# CORNWALL CONDOMINIUMS

## 2ND FLOOR CONDOMINIUM RENOVATIONS JOB NO. 201812.04

# PERMIT SET

**APPROVED**  
**Subject to Field**  
**Inspection**  
12/09/2020 4:08:46 PM  
Kelsey Brender

**NOTE:**  
 EXST. PROPERTY INFORMATION AND WATER UTILITIES SHOWN ARE AS PER CITY OF BELLINGHAM GIS INFO, AND HAVE NOT BEEN SURVEYED.

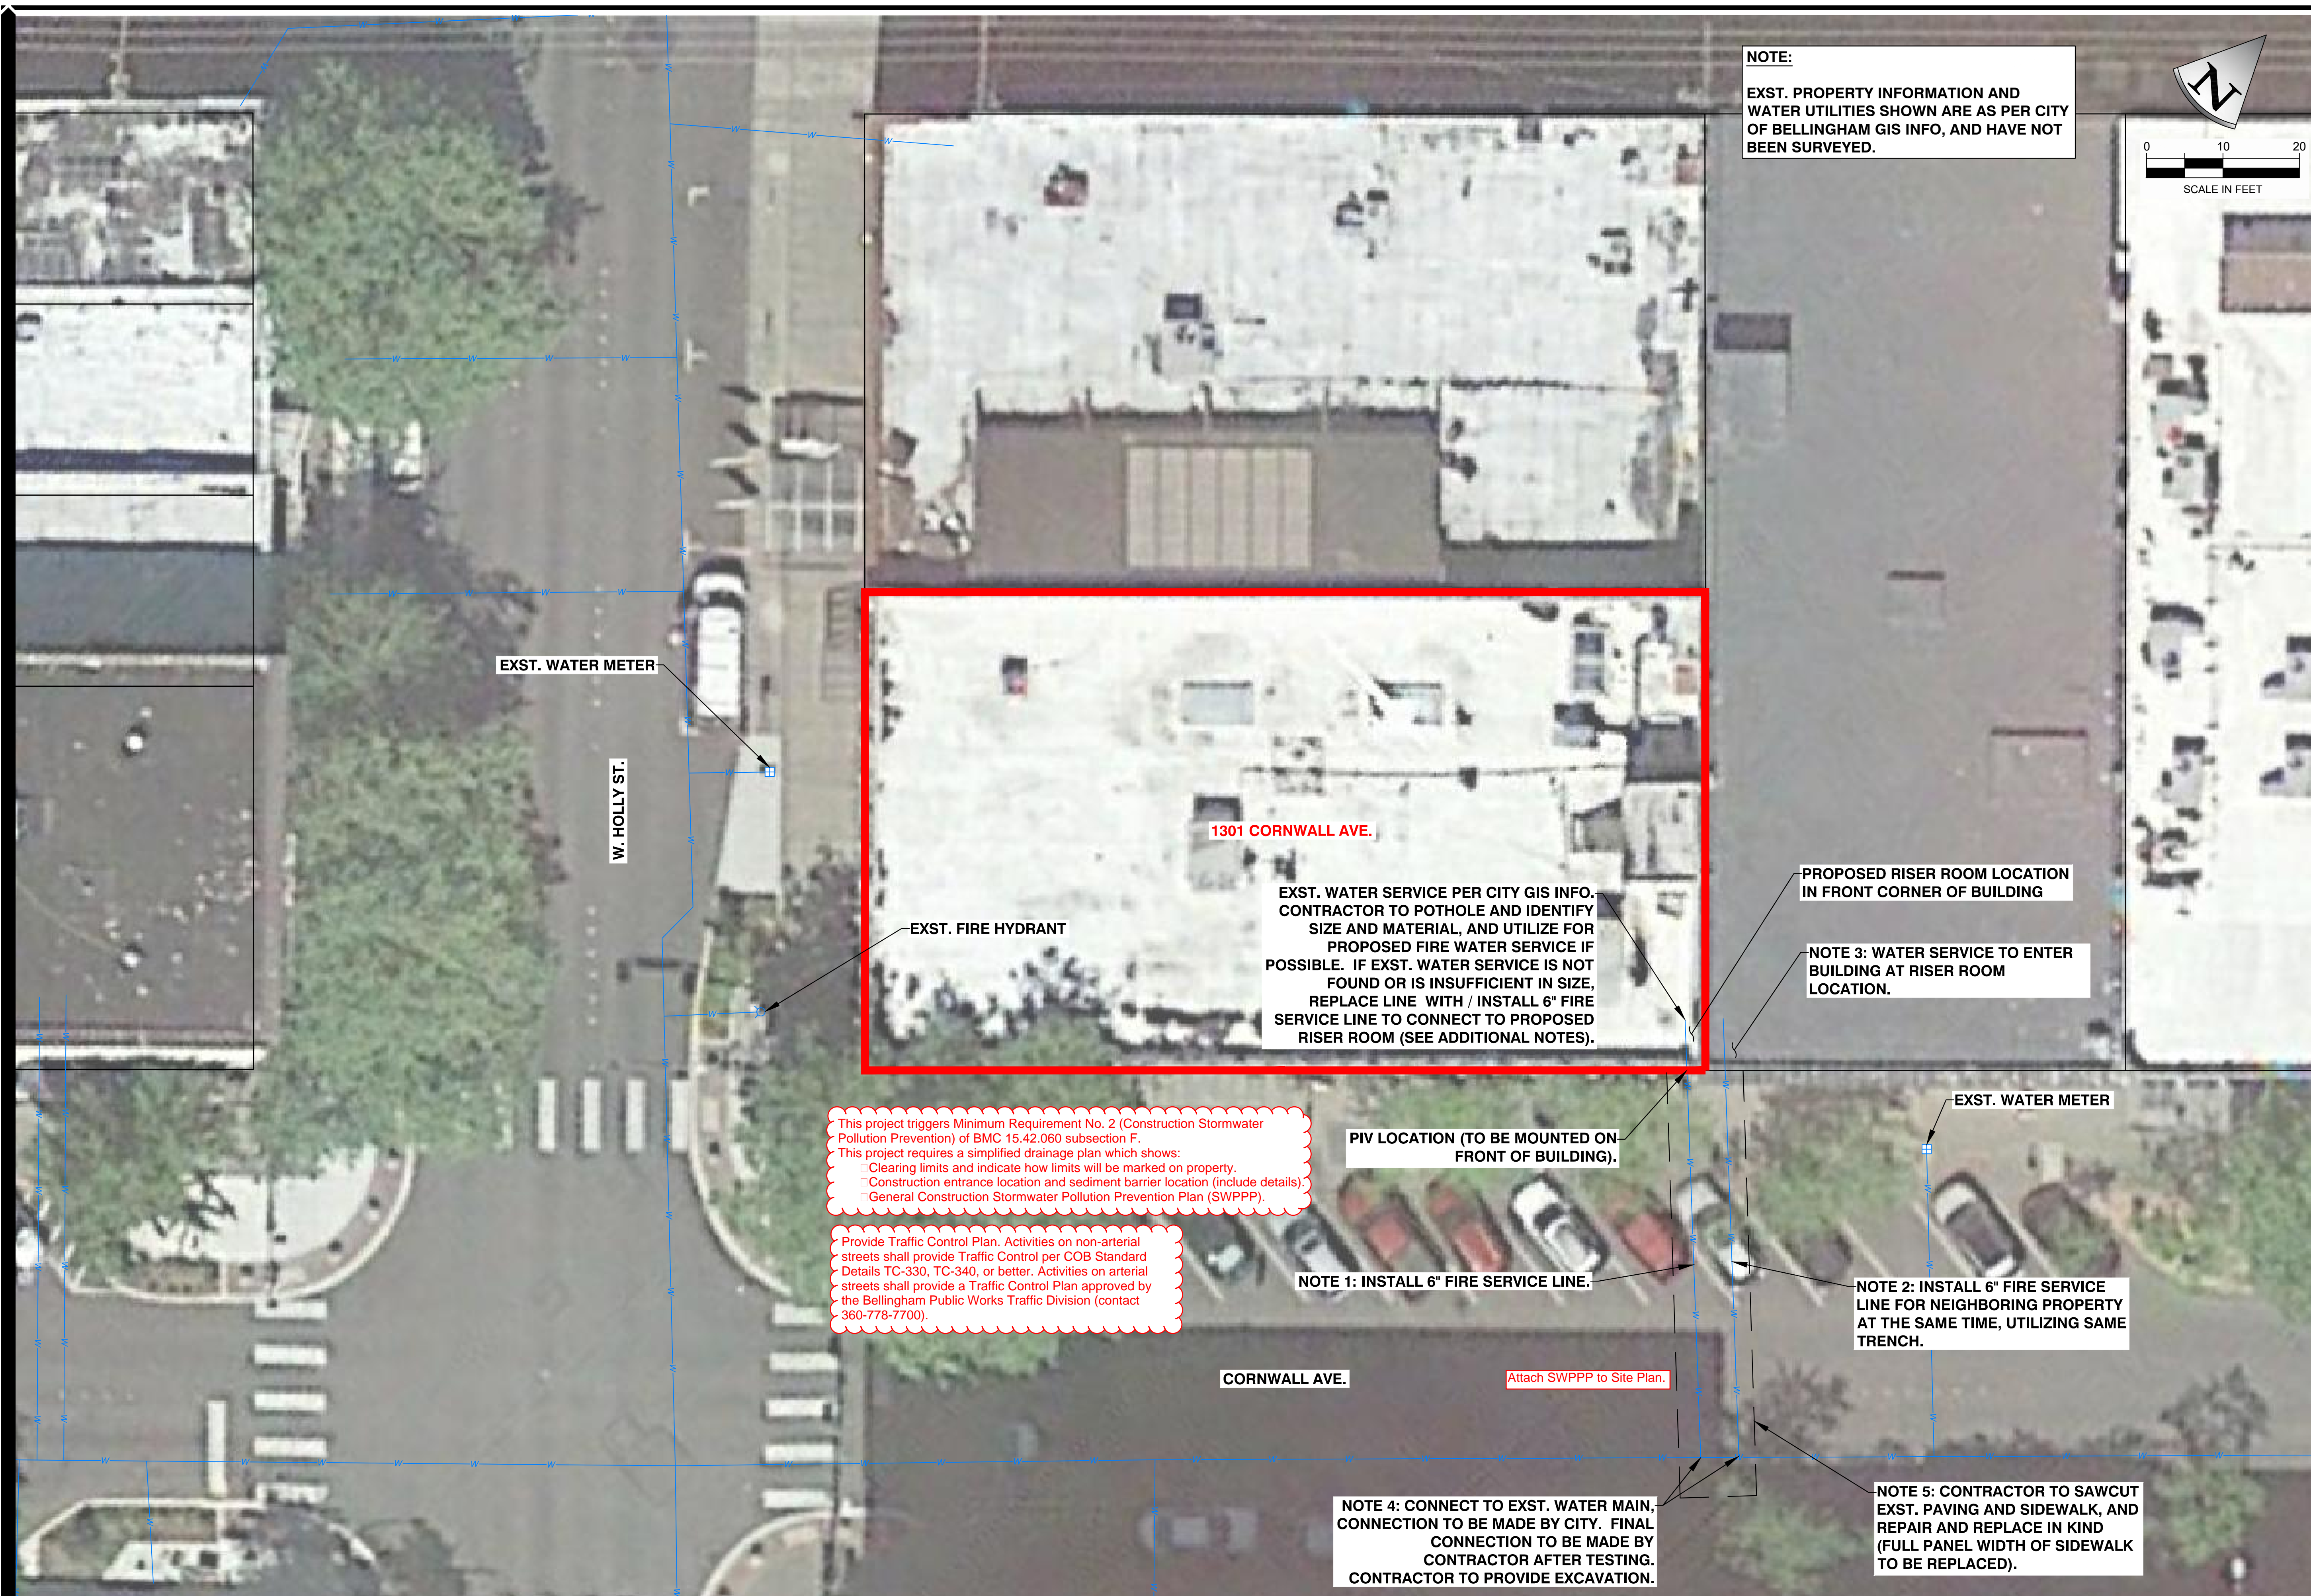
This project triggers Minimum Requirement No. 2 (Construction Stormwater Pollution Prevention) of BMC 15.42.060 subsection F.  
 This project requires a simplified drainage plan which shows:  
 Clearing limits and indicate how limits will be marked on property.  
 Construction entrance location and sediment barrier location (include details).  
 General Construction Stormwater Pollution Prevention Plan (SWPPP).

Provide Traffic Control Plan. Activities on non-arterial streets shall provide Traffic Control per COB Standard Details TC-330, TC-340, or better. Activities on arterial streets shall provide a Traffic Control Plan approved by the Bellingham Public Works Traffic Division (contact 360-778-7700).

Attach SWPPP to Site Plan.

CITY OF BELLINGHAM, WA  
**CORNWALL CONDOMINIUMS  
FIRE WATER SERVICE  
CONSTRUCTION DETAILS**

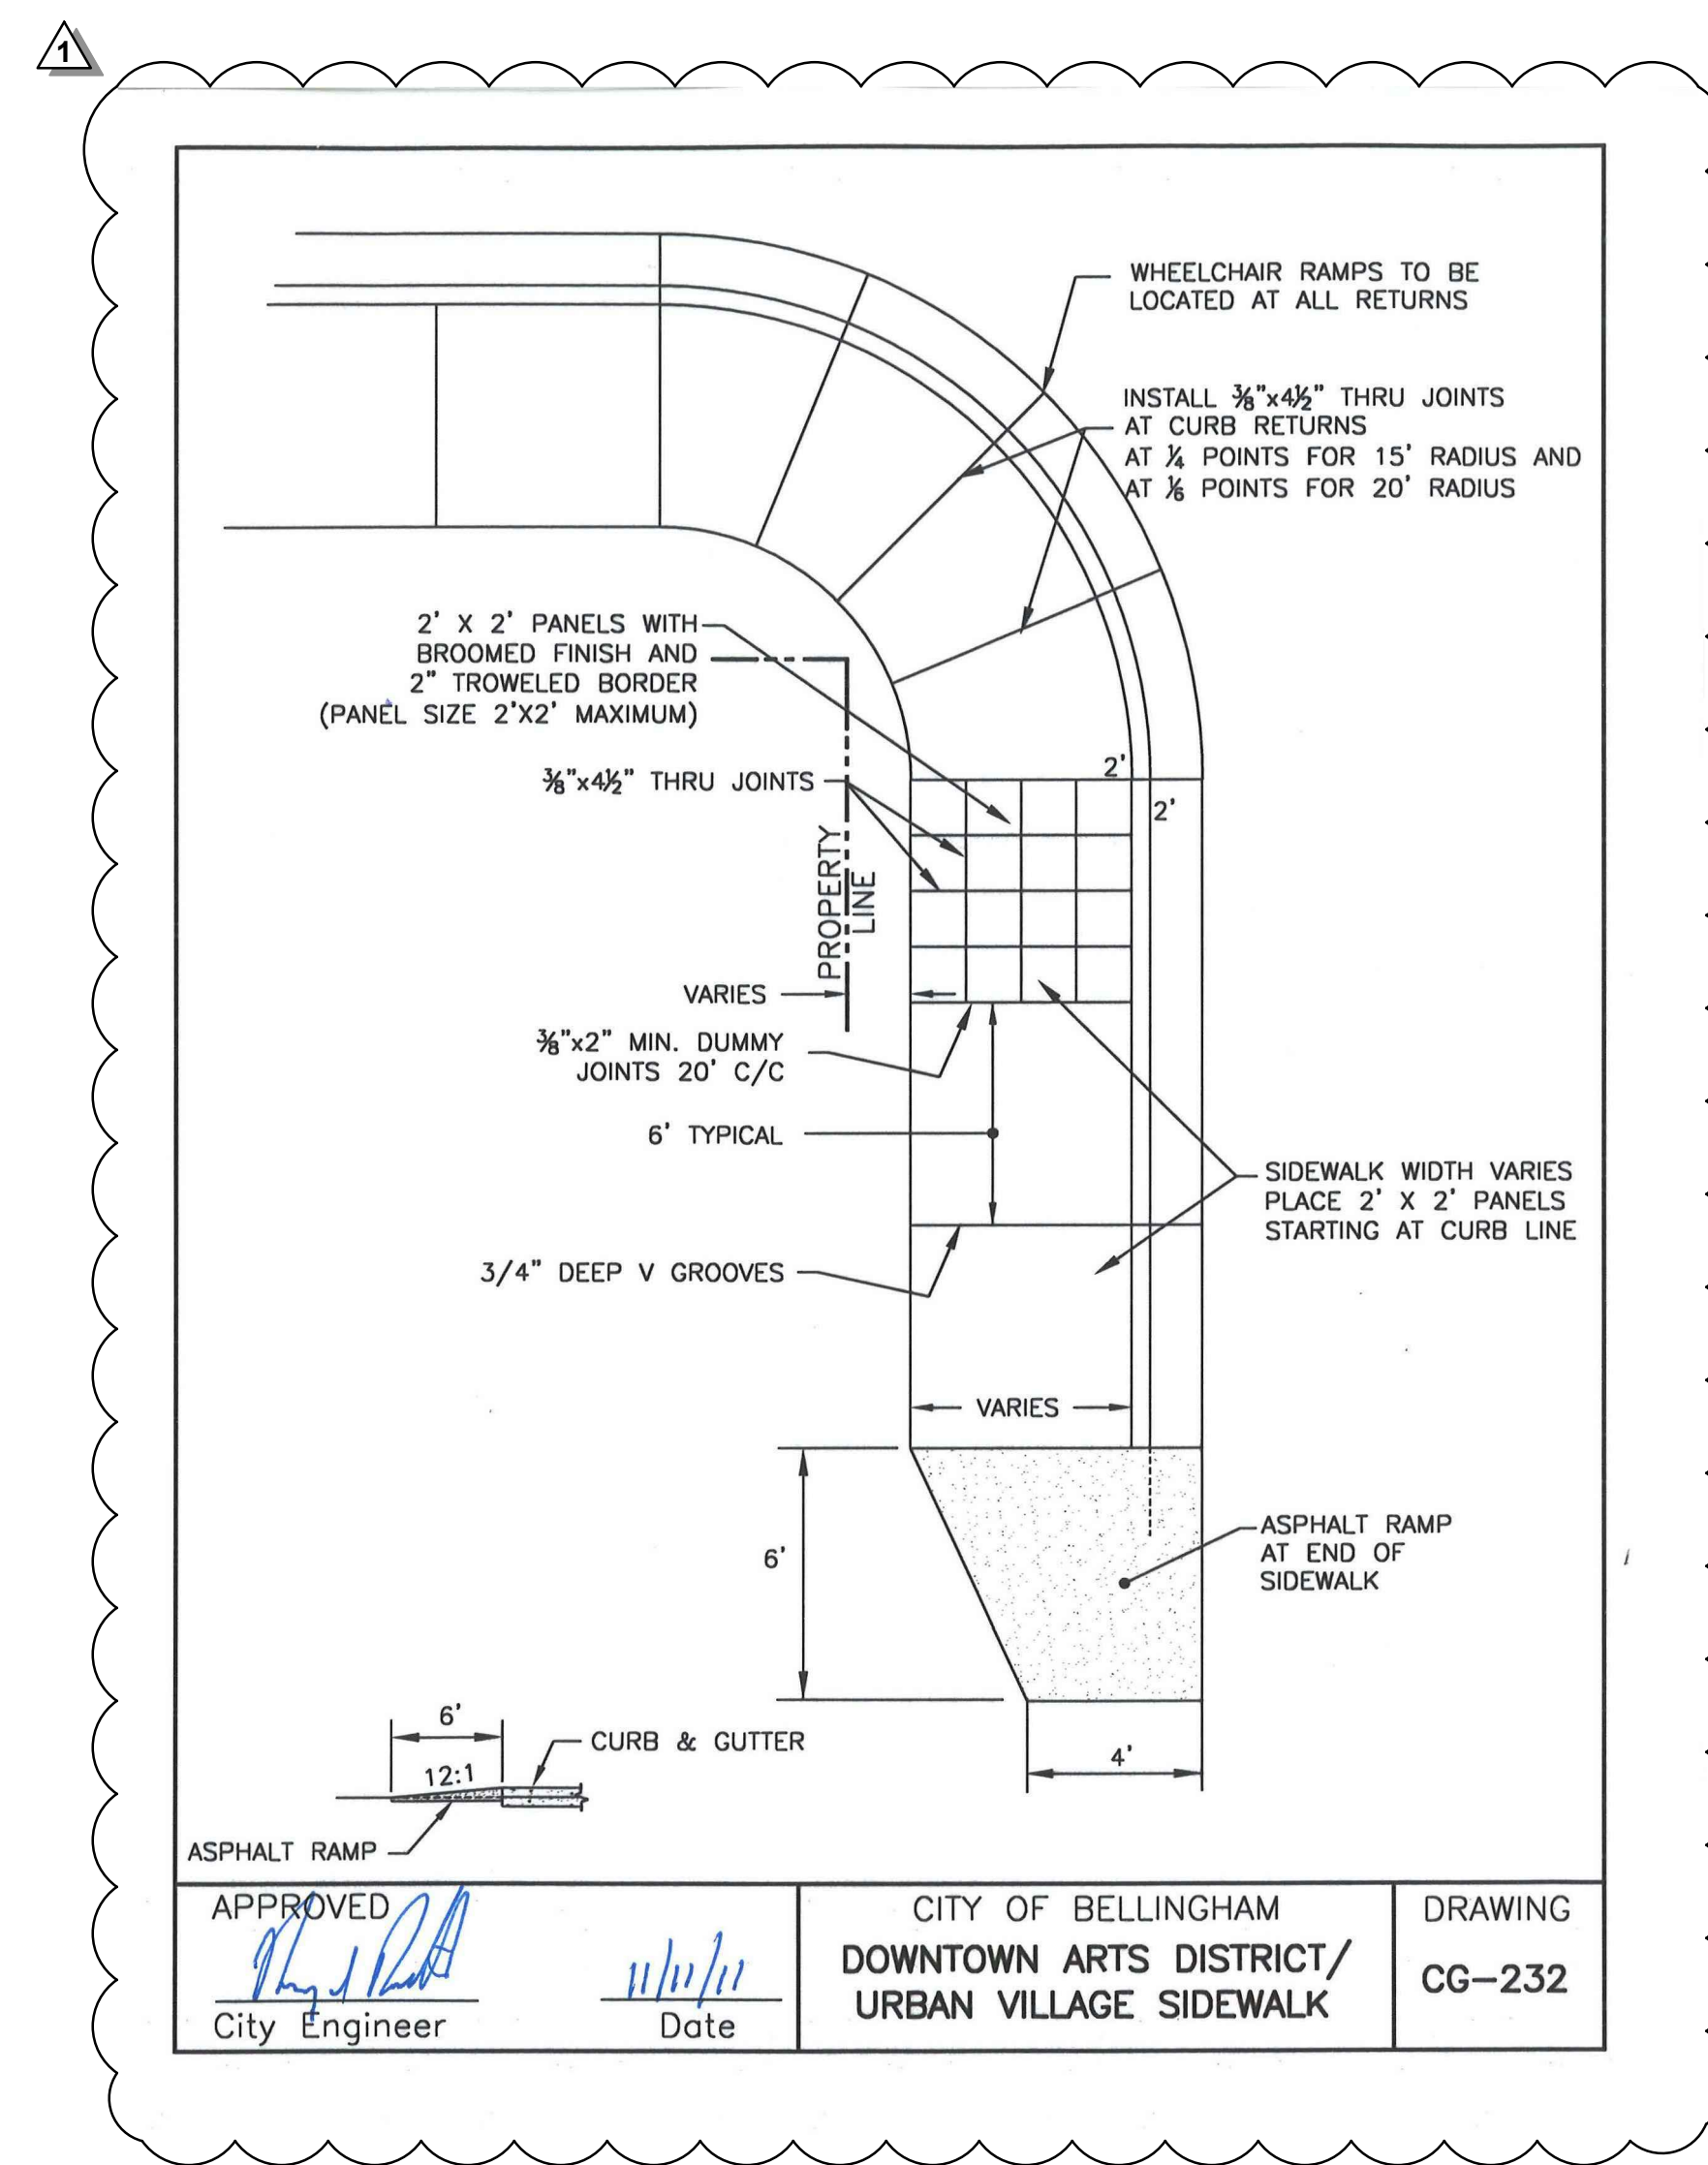
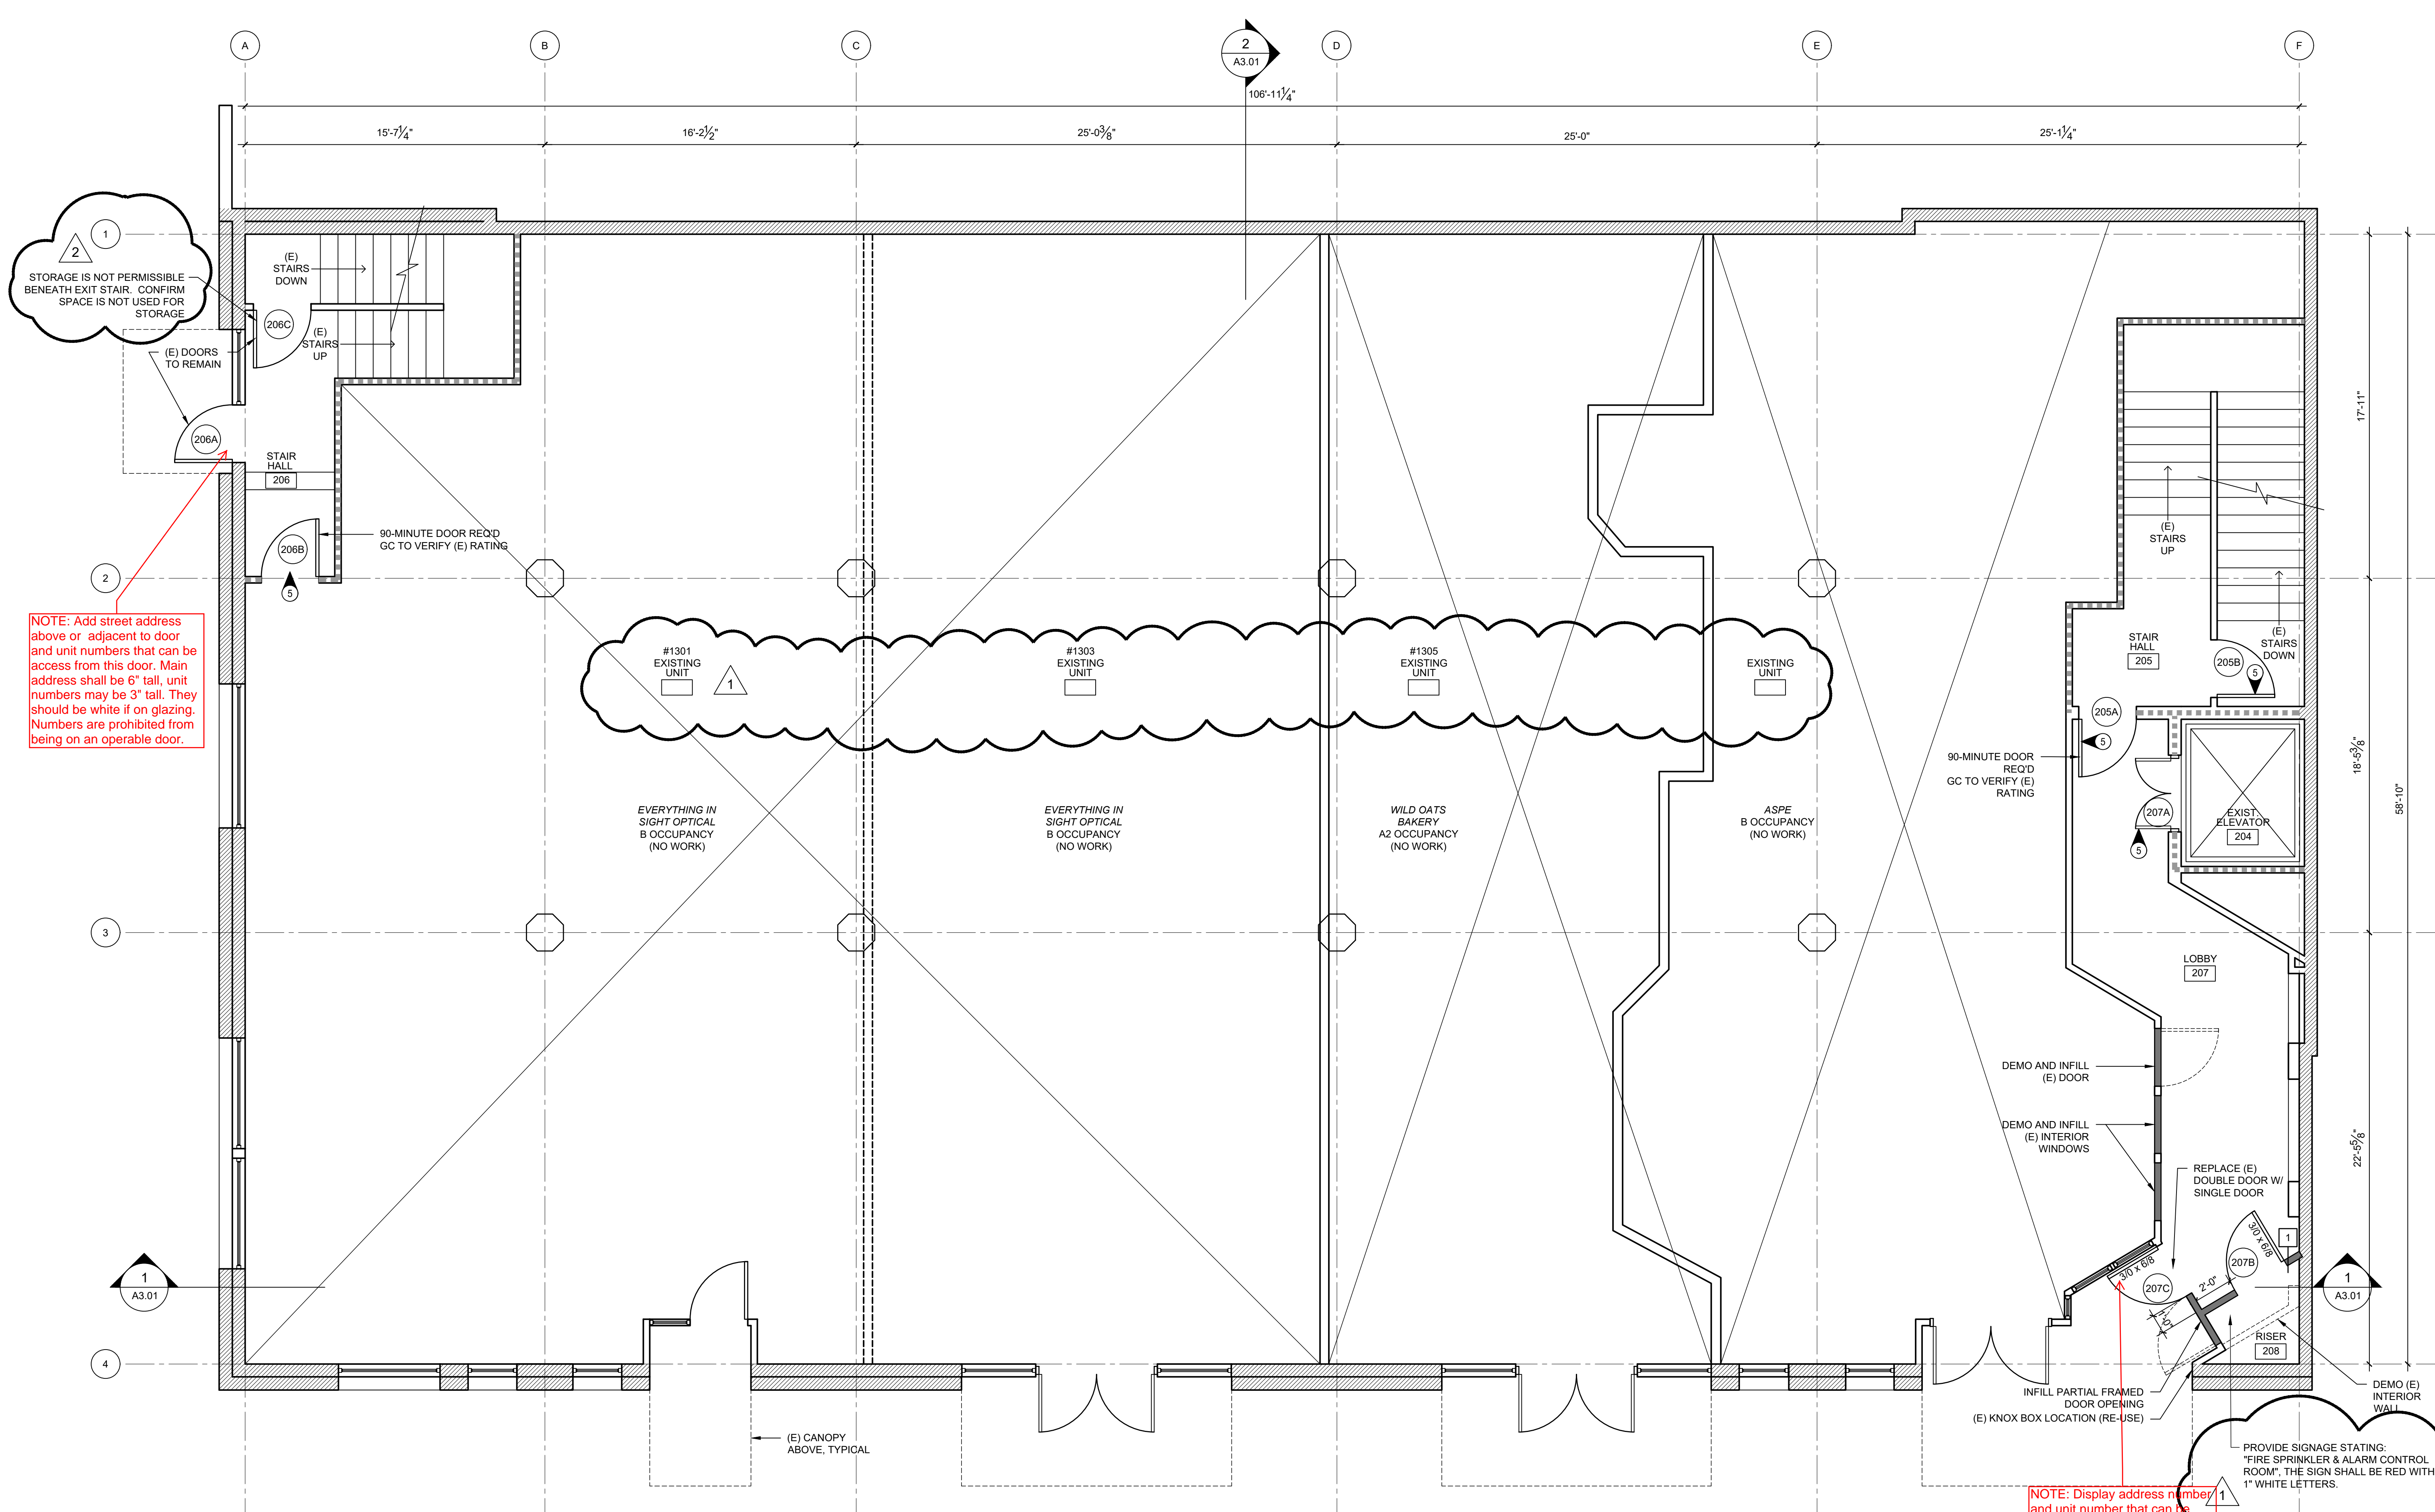
CITY COMMENTS-UPDATED DETAIL  
REVISIONS  
DATE 9/11/2020  
BY ELR
